**Subject: Former Lockheed Martin Corporation, International Light Metals Facility
Clarification of Off-Site Groundwater Investigation Work Plan Submittal**

**OFFSITE GROUNDWATER CHARACTERIZATION WORKPLAN:
LOCKHEED MARTIN CORPORATION, TORRANCE, CALIFORNIA
(EPA ID NO. CAD030398622)**

SUBJECT: OFF-SITE GROUNDWATER CHARACTERIZATION
WORKPLAN, LOCKHEED MARTIN CORPORATIONMAY 14 1998
FMB - PERMITTINGPete Wilson
GovernorPeter M. Rooney
Secretary for
Environmental
Protection

**OFFSITE GROUNDWATER CHARACTERIZATION WORKPLAN:
LOCKHEED MARTIN CORPORATION, TORRANCE, CALIFORNIA
(EPA ID NO. CAD030398622)**

ATTACHMENT A

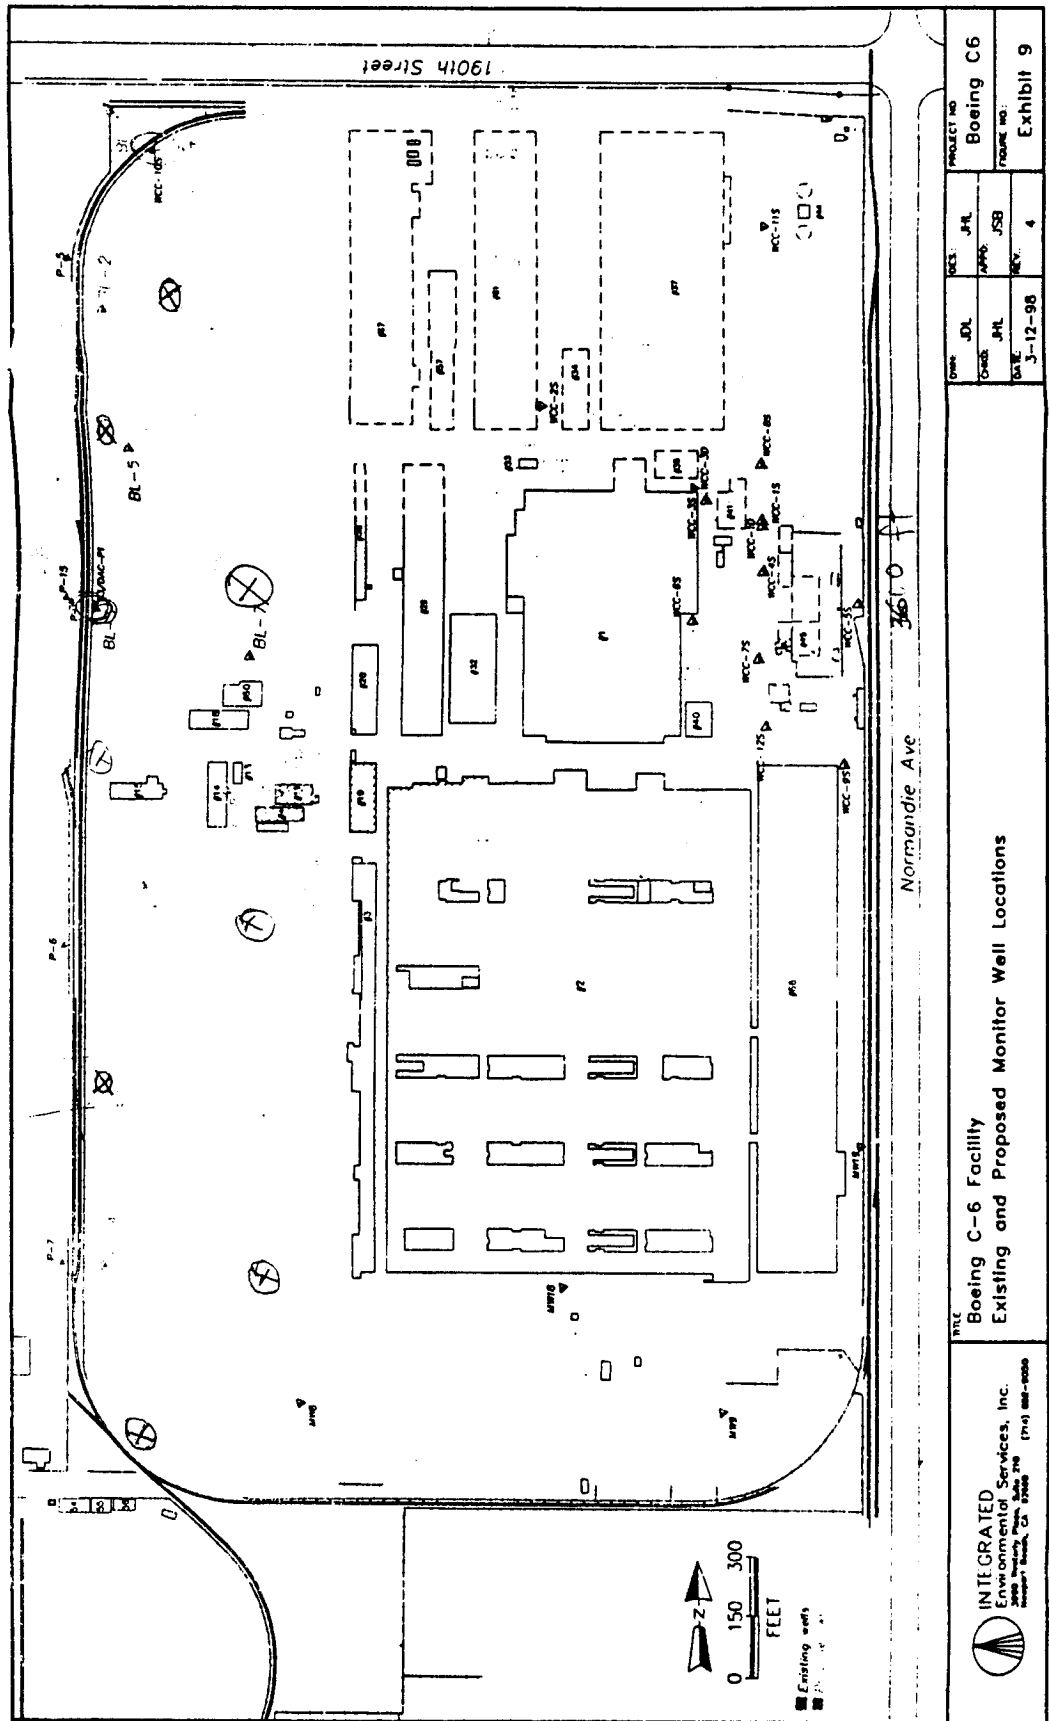
1. The well locations shall be revised in accordance with locations specified in Attachment A. This Attachment was shared with LMC and Boeing Realty Corporation (BRC) at a June 1, 1998 meeting. A revised map showing the new locations shall be submitted to DTSC for approval.

⊗ Suggested well location per June 1, 1998 meeting
